**Memorandum of Understanding
between
Equus Beds GMD2
and
The City of Wichita**

**Regarding the Proposed Aquifer
Storage and Recovery Project
Phase 1**

ASR Items of Understanding

Attachment A. – Application No. 45570 Site Map - NW 08-23S-2W
Prepared by: Equus Beds Groundwater Management District No. 2 - 07/06/04

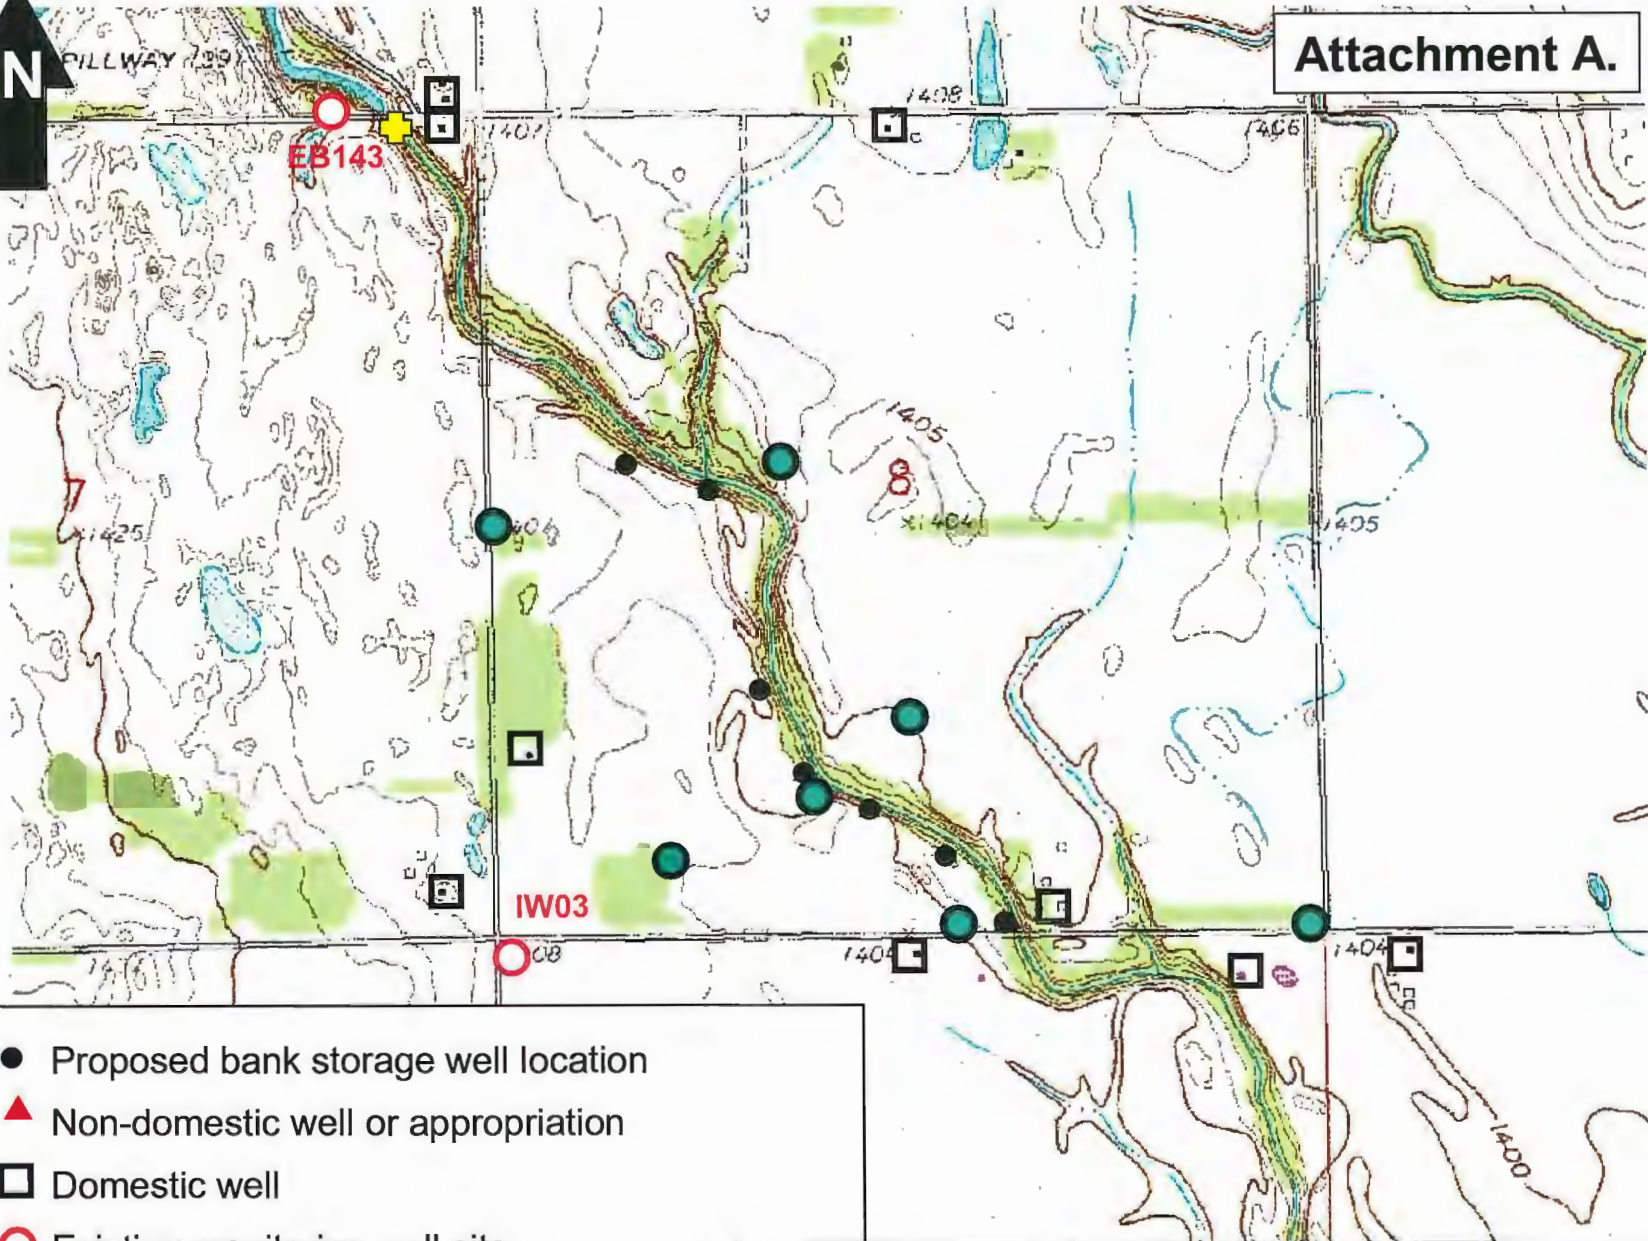
The City's initial plans are for bank storage wells to be screened in the lower parts of the aquifer because of water quality and well efficiency concerns. The GMD2 is concerned about screening the bank storage wells in the lower aquifer zone. The GMD2 consultant has suggested a tes of the upper aquifer zone.

The City will install one shallow test well at one diversion well site to determine the approximate yield, water quality and connectivity to the river. The test plan will be developed in consultation with GMD2 staff.

Figure 4. –
Example of
Lithologic Log
and Construction
Design for
Bank Storage
Well

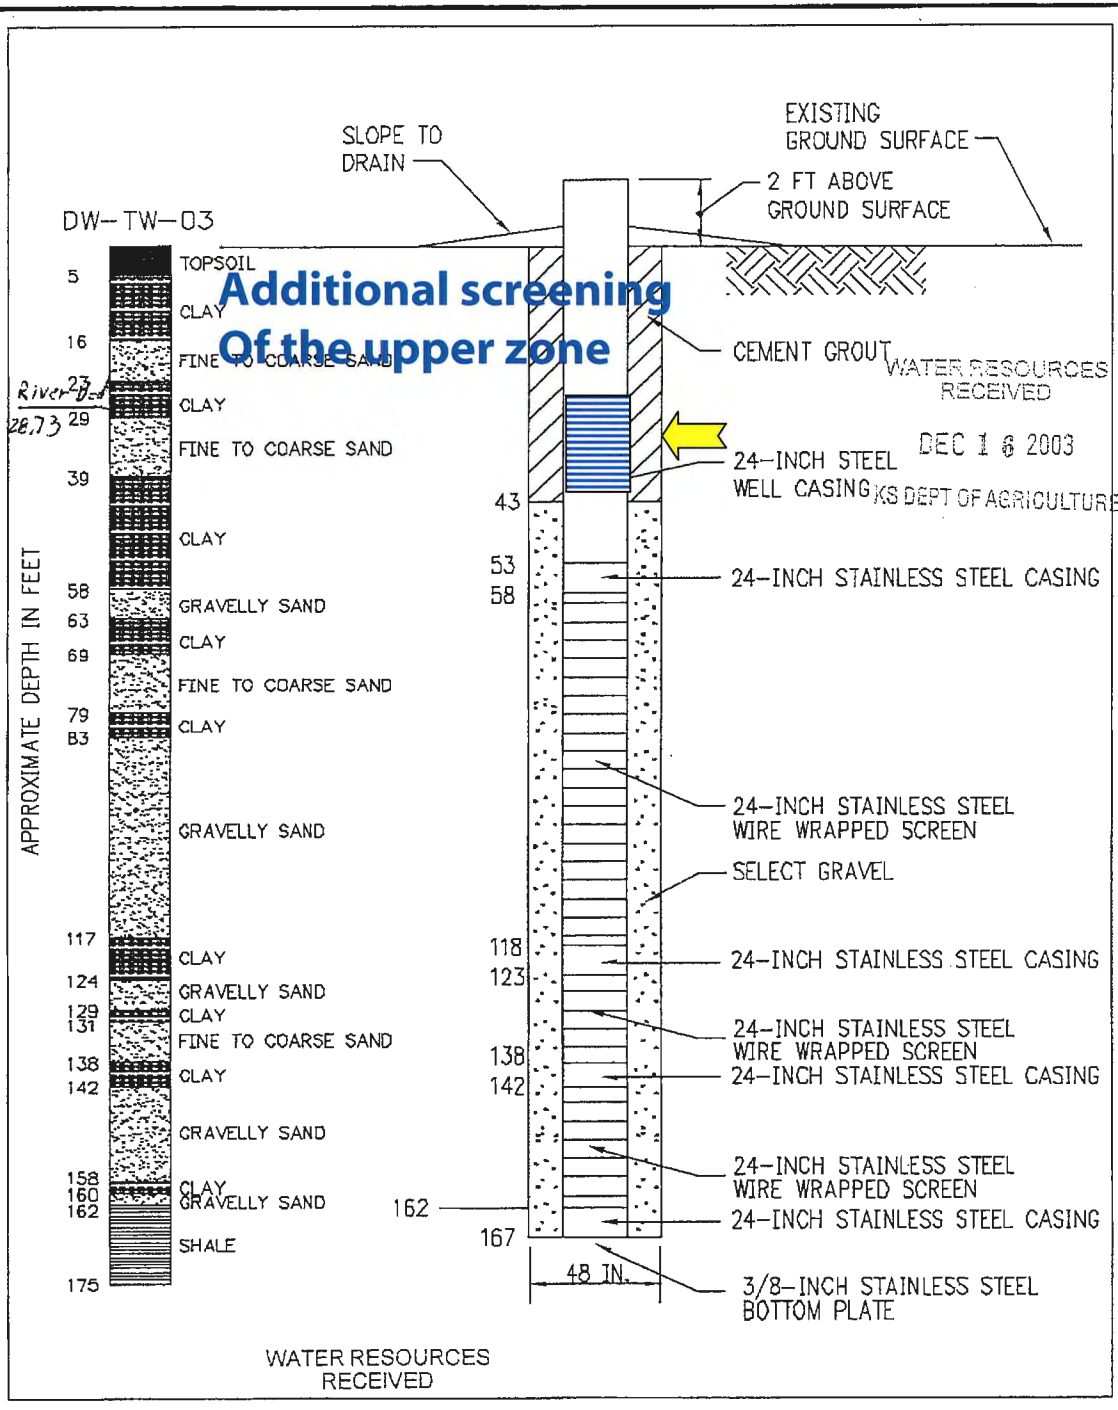
As addressed in item 2, the City's initial plans were for the bank storage diversion wells to be screened in the lower parts of the aquifer because of water quality and efficiency concerns. The GMD2 consultant recommended also screening the upper aquifer zones to alleviate GMD2 concerns about the diversion wells being screened only in the lower aquifer zone.

The City will design bank storage diversion wells screened in the upper (where present) as well as the lower sand zones. If the upper sand zone adversely affects water quality to an unacceptable amount, the City may seal it after consultation with GMD2 staff.

Attachment 45567-A. – Application No. 45567 Site Map - NW 25-23S-3W
Prepared by: Equus Beds Groundwater Management District No. 2 - 07/06/04

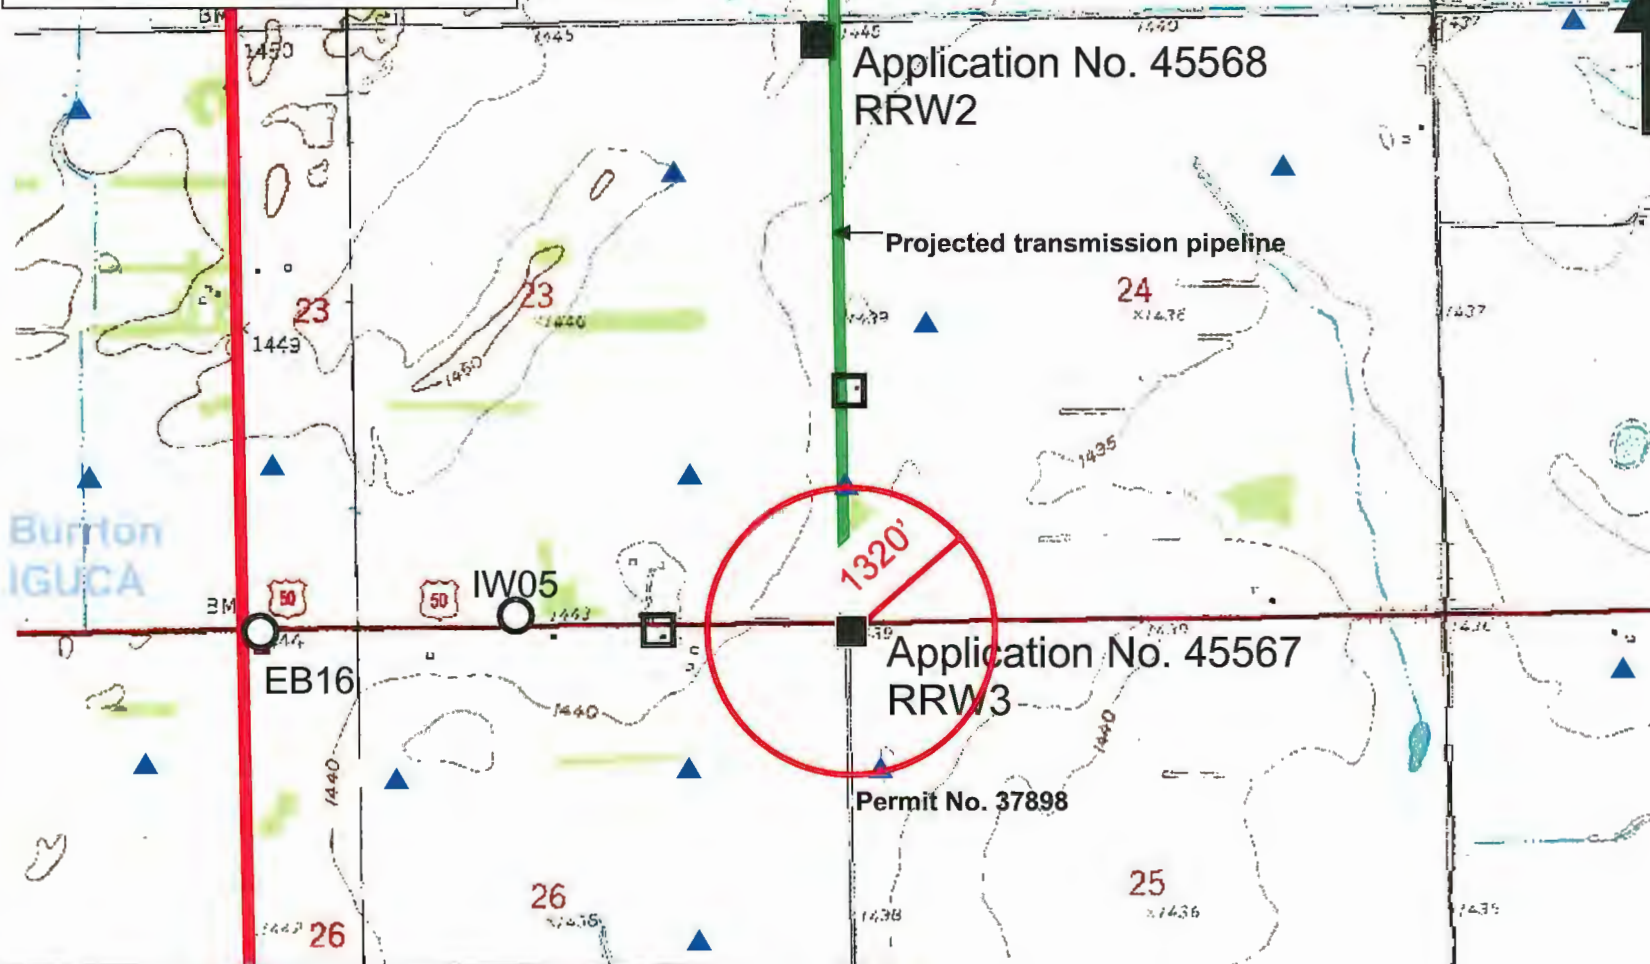
Recommendation No. 1

Attachment 45567-A(r). – Application No. 45567 Site Map - NW 25-23S-3W
Prepared by: Equus Beds Groundwater Management District No. 2

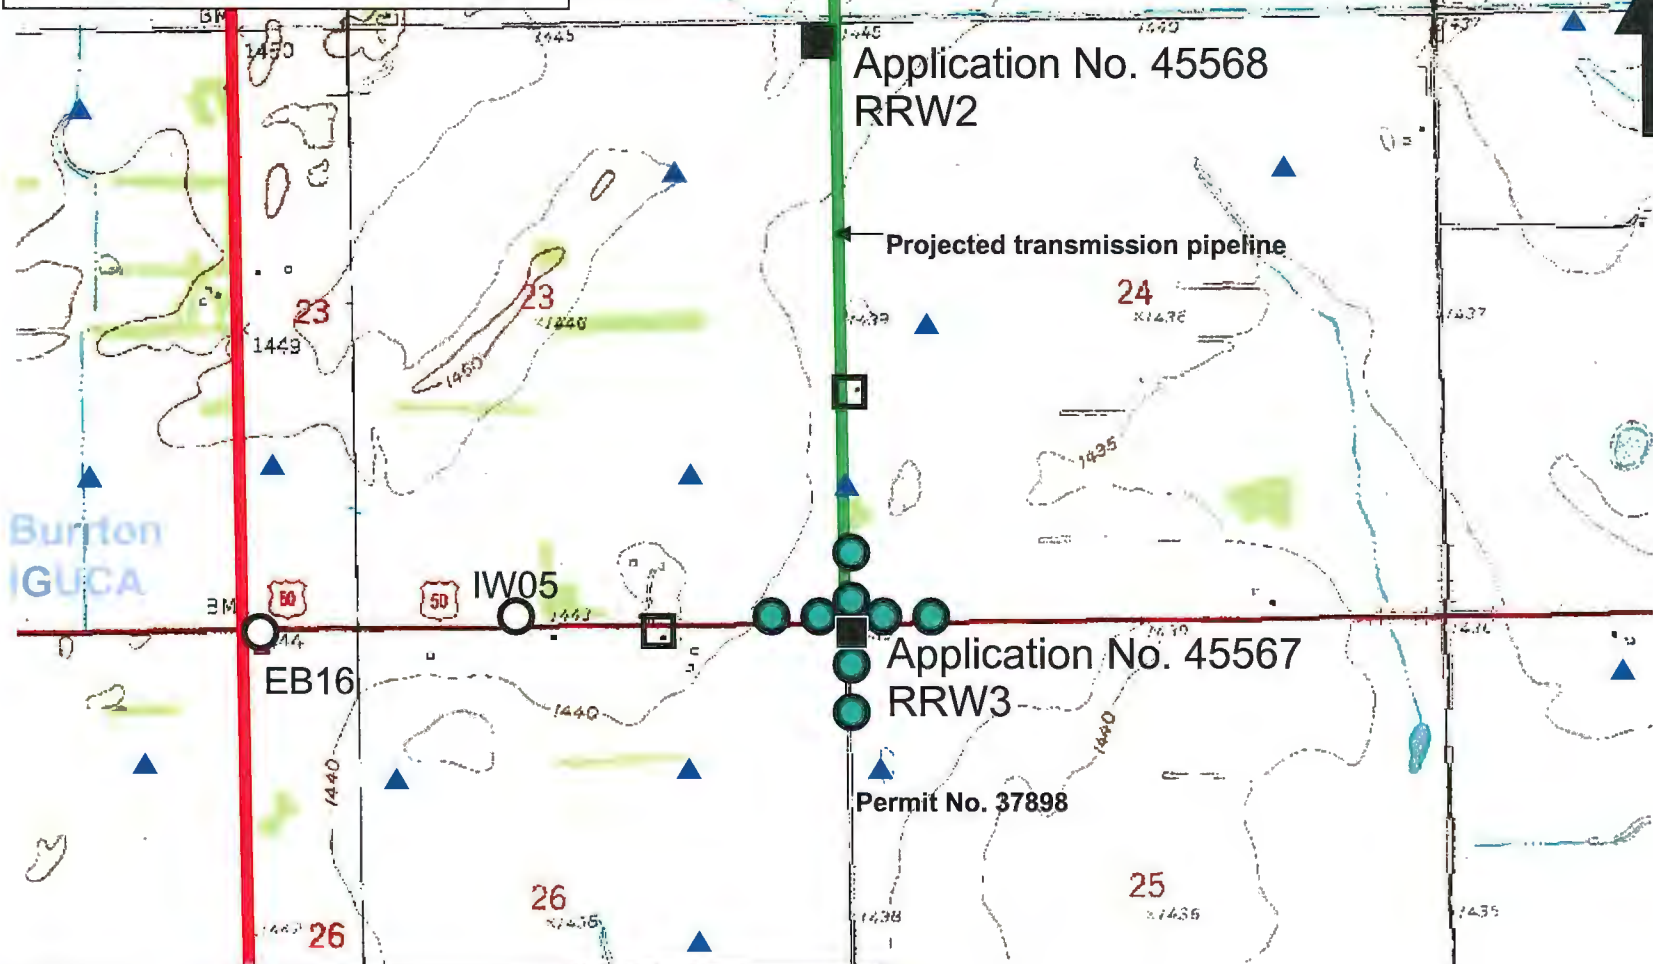
Recommendation No. 16

Attachment 45568-A(r). – Application No. 45568 Site Map - NE 23-23S-3W
Prepared by: Equus Beds Groundwater Management District No. 2

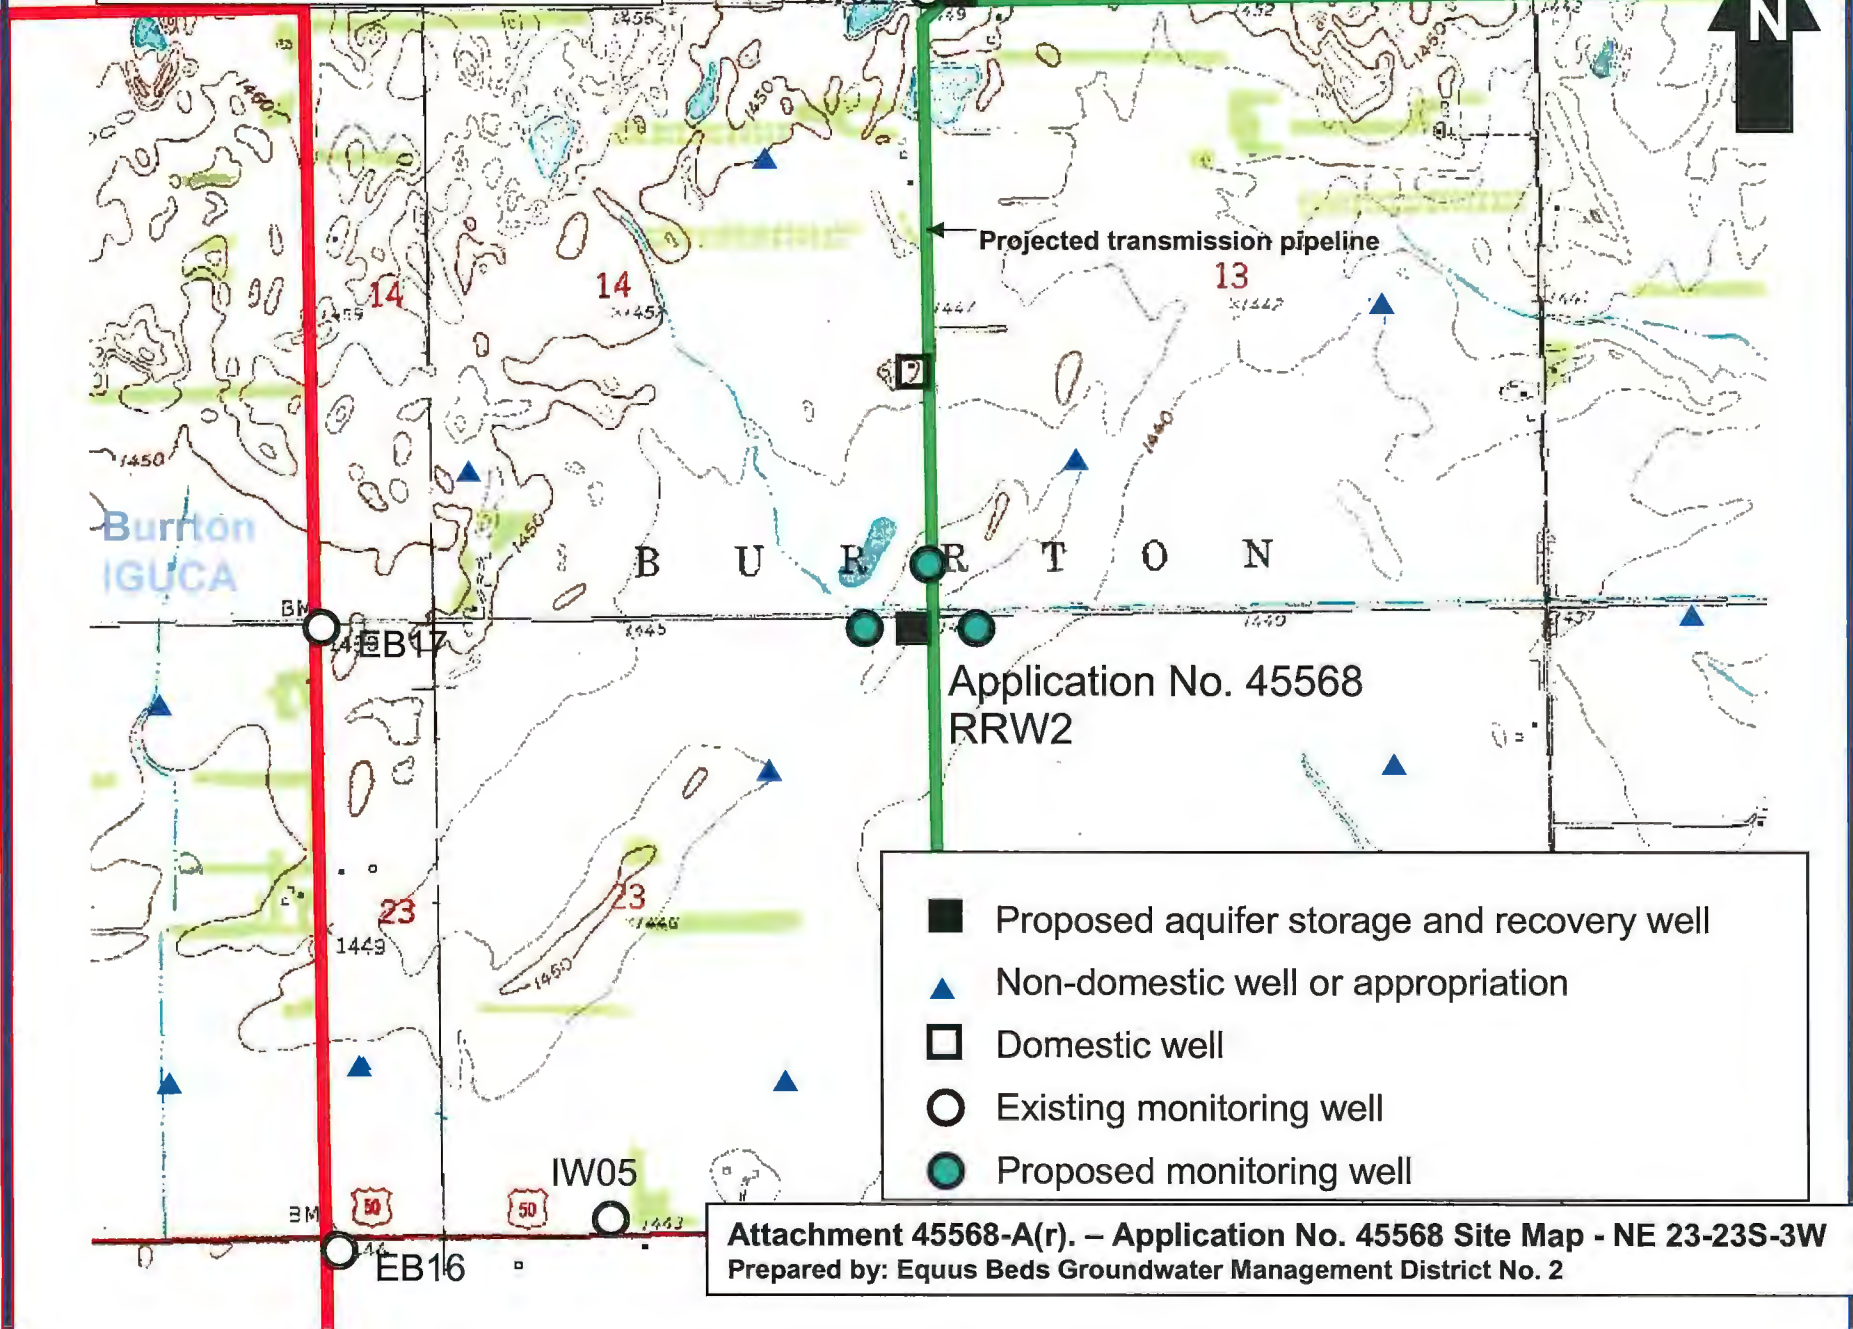
Recommendation No. 15

Attachment 45576-A(r). – Application No. 45576 Site Map - SW 12-23S-3W
Prepared by: Equus Beds Groundwater Management District No. 2

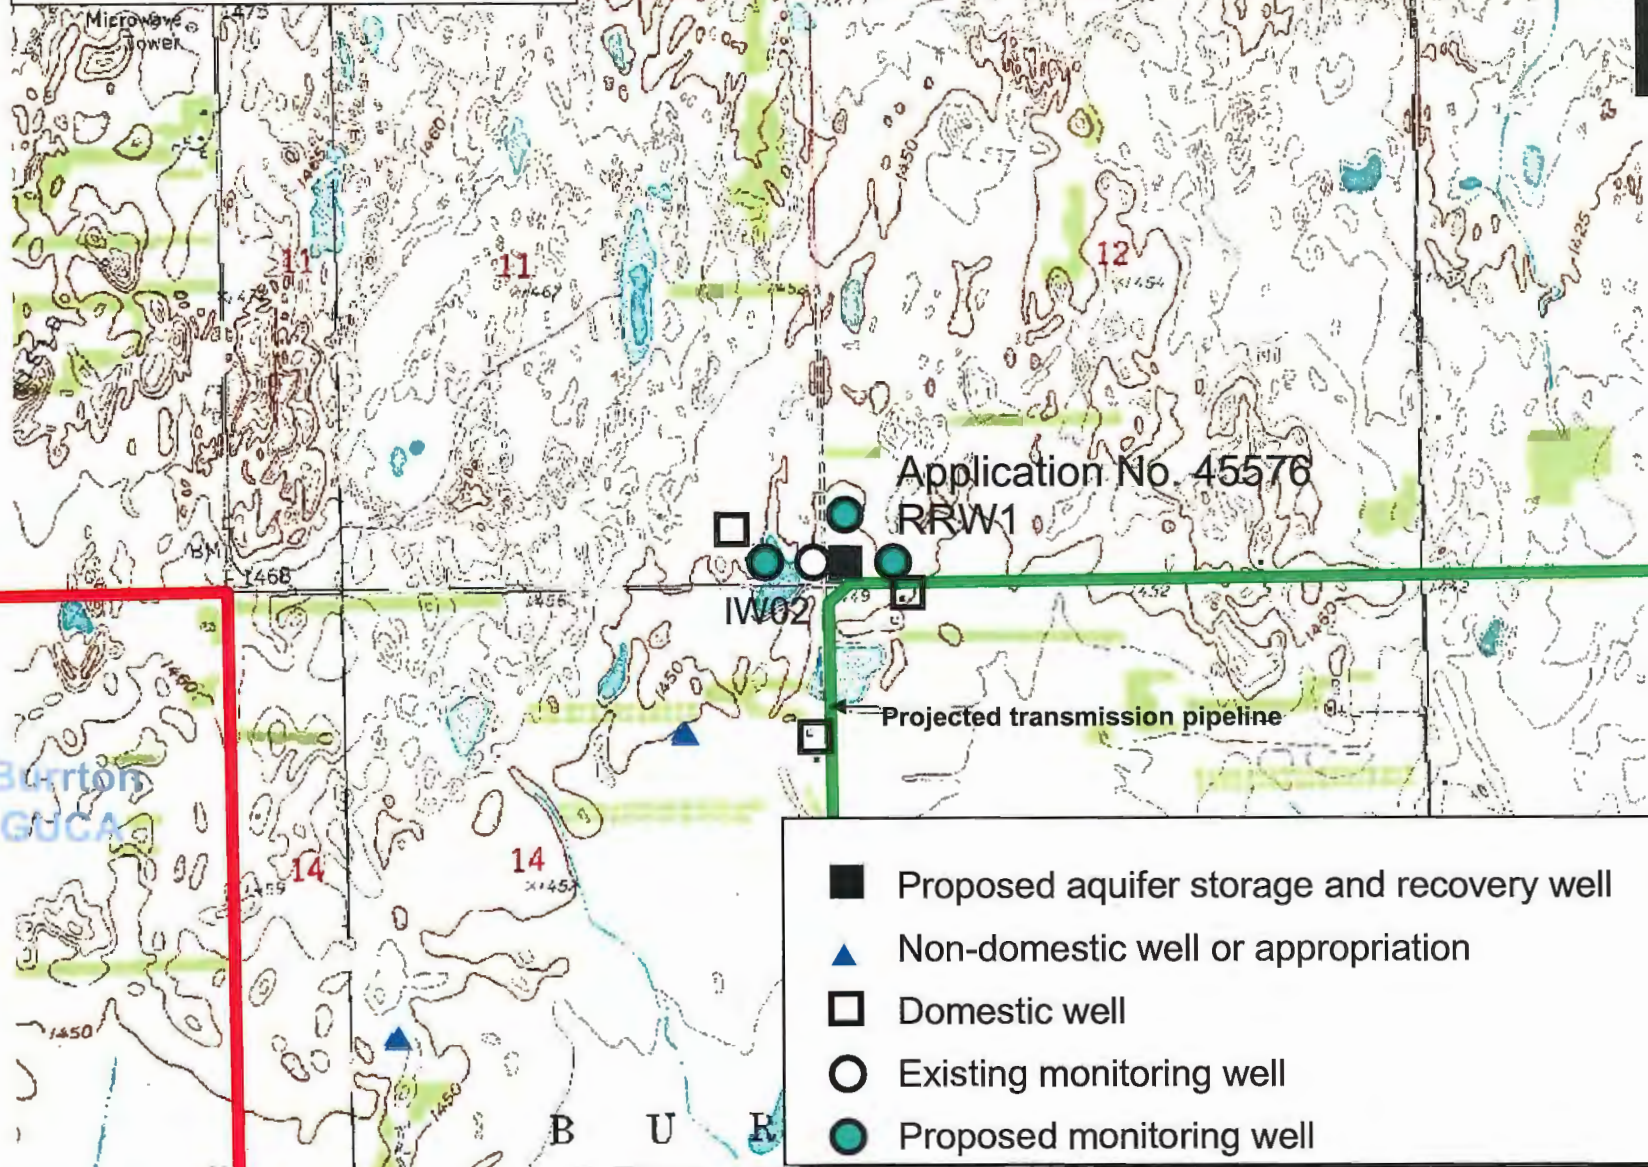
Recommendation No. 15
